DATE: 12/7/23

SUBJECT: ADDENDUM NO. 2 TO THE BIDDING DOCUMENTS FOR

CDB-818-010-103  
REPAIR AND REPLACE ROOFS – PHASE 3  
WESTERN ILLINOIS UNIVERSITY  
ILLINOIS BOARD OF HIGHER EDUCATION  
MACOMB, MCDONOUGH COUNTY, ILLINOIS

ISSUED FOR BID

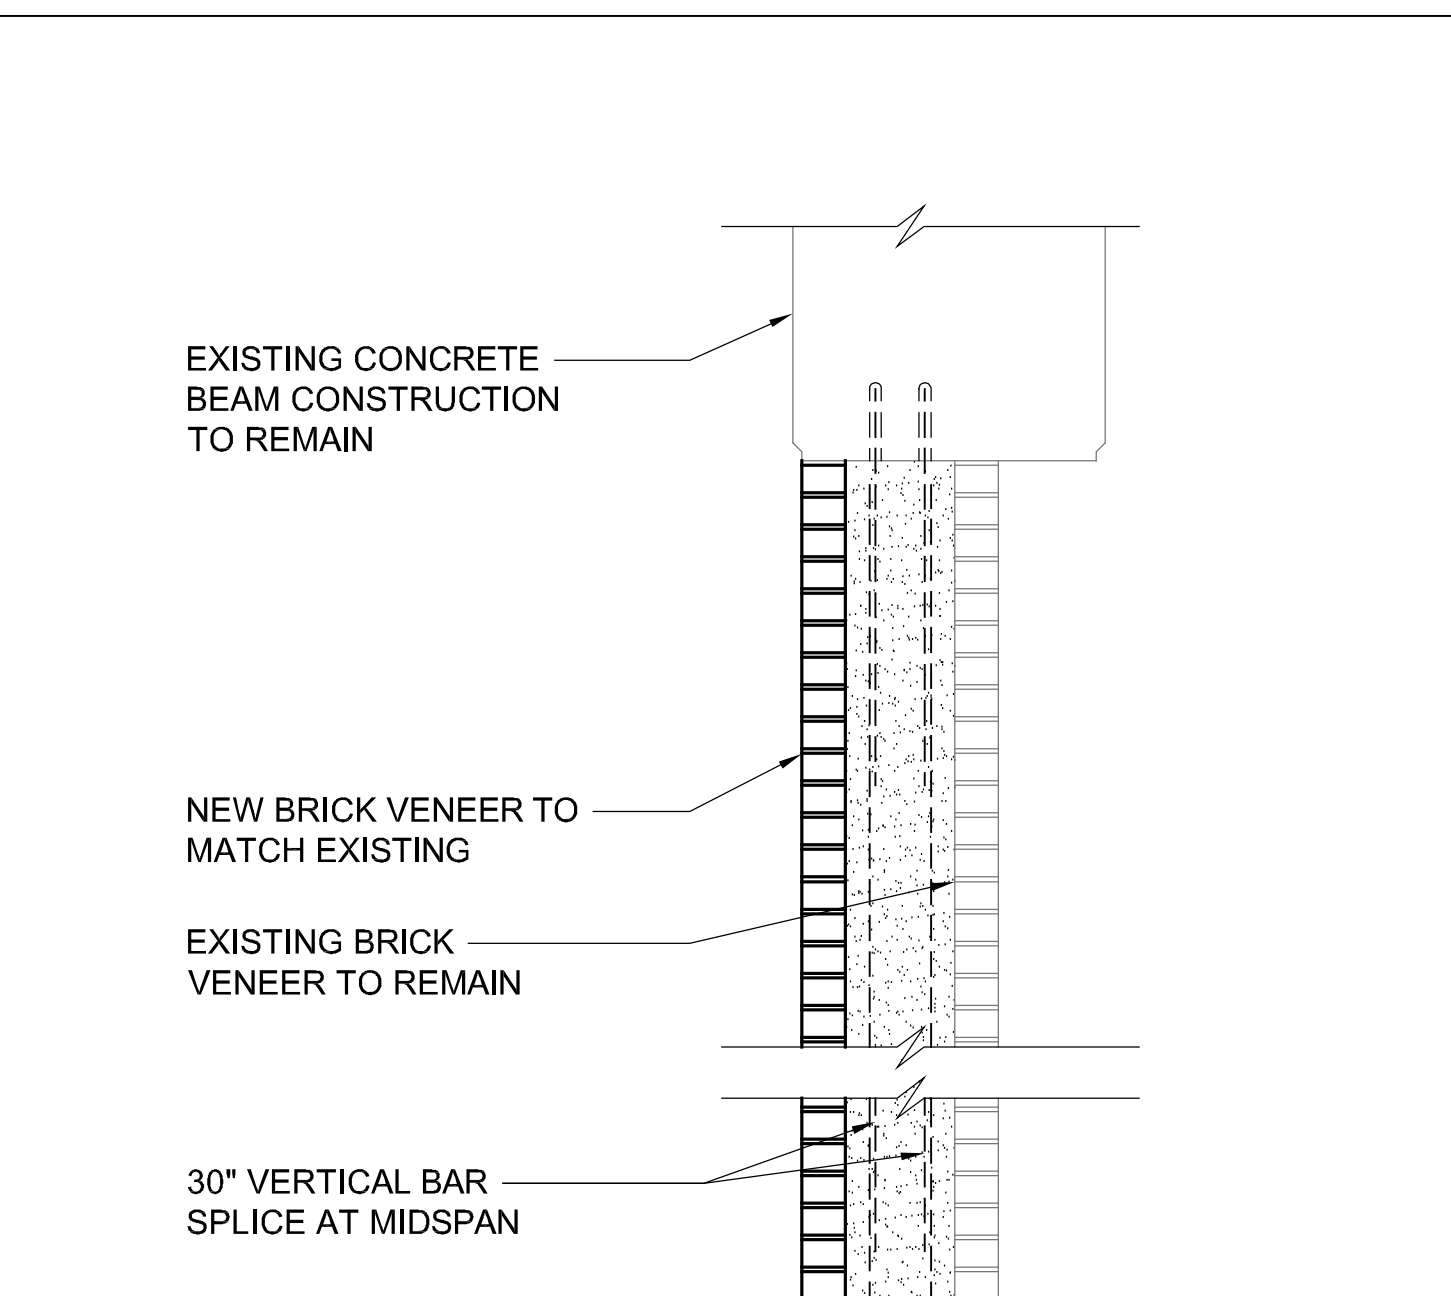
9. SHEET A502: Detail 1 has been revised to show the proper flashing and insulation thickness.
